RS-18-102

August 10, 2018

Byron Station, Units 1 and 2  
Renewed Facility Operating License Nos. NPF-37 and NPF-66  
NRC Docket Nos. STN 50-454 and STN 50-455

Subject: License Amendment Request for a One-Time Extension to Technical  
Specification 3.8.1, "AC Sources-Operating," Required Action A.2

**Figure 6:** Simplified Drawing of a Portion of the Byron Station, Units 1 and 2 Electric Power System with Temporary Alignment Highlighted (For Information Only)

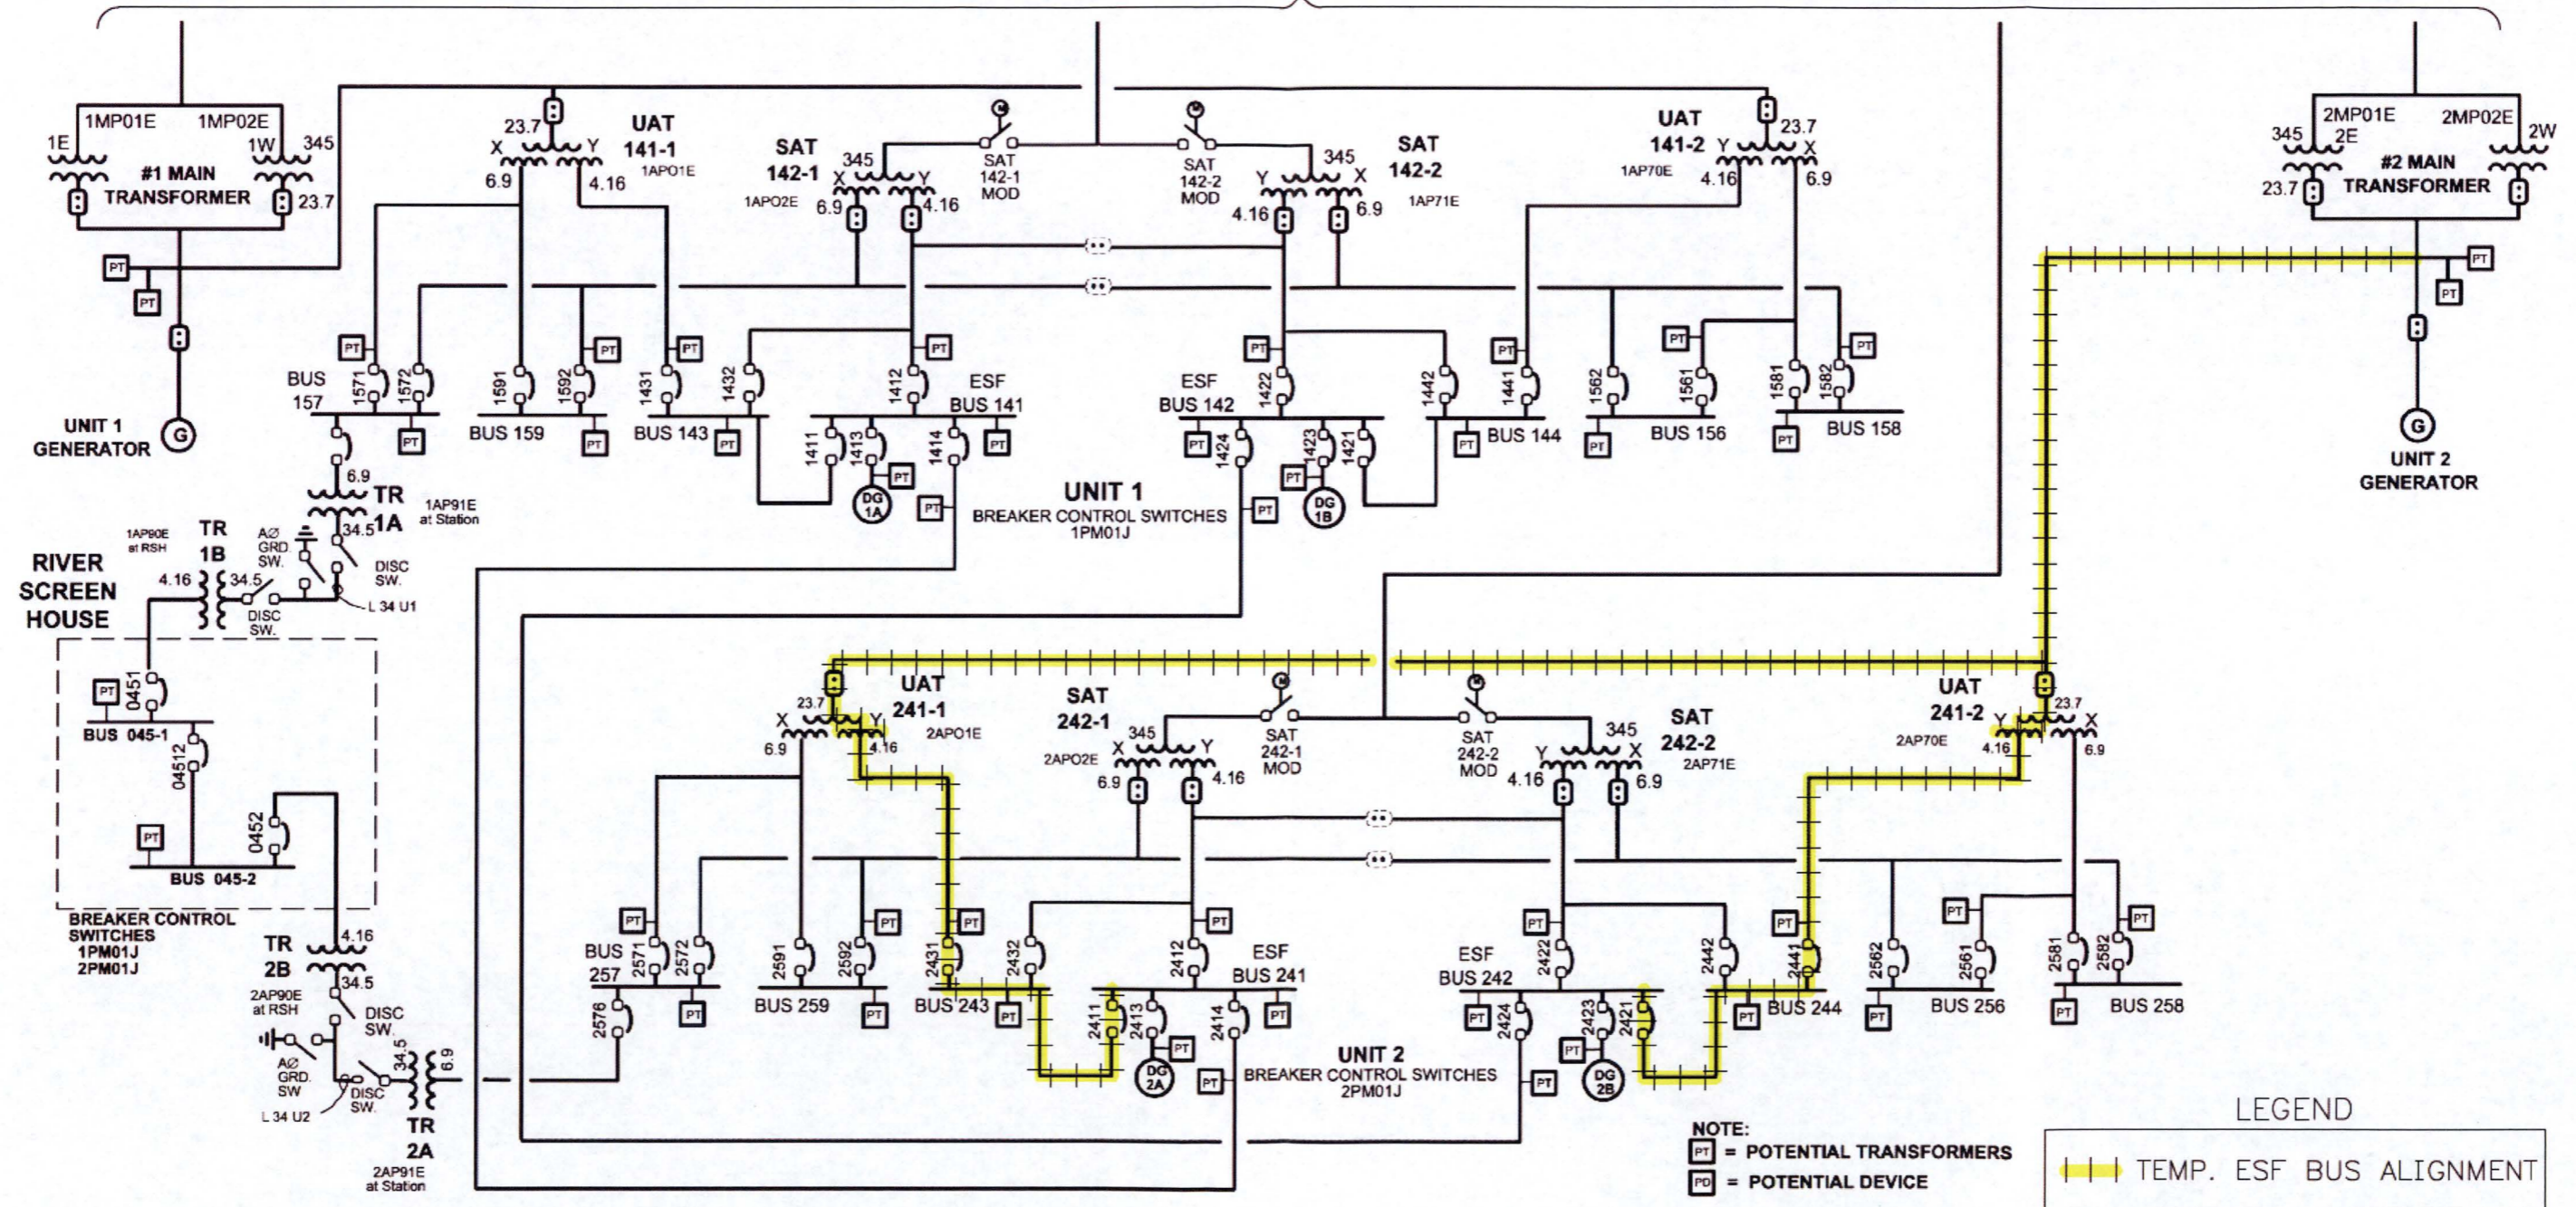
Following an unanticipated failure of SAT 242-1, the EGC intends to implement a modification to restore power to Buses 241 and 242 from Buses 243 and 244 via Breakers 2411 and 2421, respectively. Bus 243 is powered from Unit Auxiliary Transformer (UAT) 241-1 and Bus 244 is powered from UAT 242-2, which receive power from the output of the Unit 2 main generator.

Figure 6 below is a simplified drawing of a portion of the Byron Station AC electric power system including a depiction of the alternate lineup that will be utilized during the requested extended Completion Time. This is the alignment that was assumed in the analysis of plant risk during the extended Completion Time as discussed in Section 4.3 below and Attachment 7 to this request.
